1st Questionnaire to the exemption request for 2016-3

Exemption for “cadmium in video cameras designed for use in environments exposed to ionising radiation”

Figure 1: Schematic Representation of the Target Structure

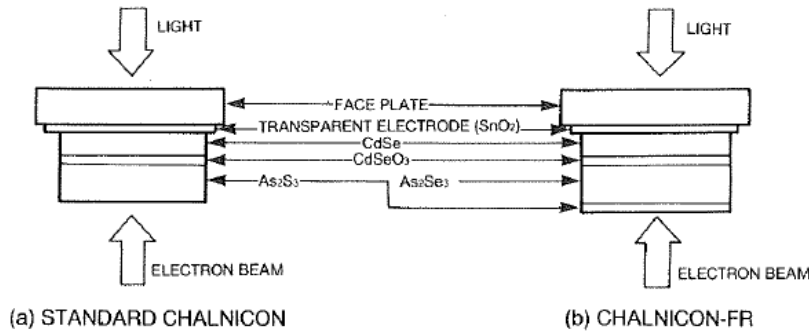
- Could you please provide a description and an illustration of the video tube (photo or drawing) in order to show where the CdSe is applied?

- **Answer:**
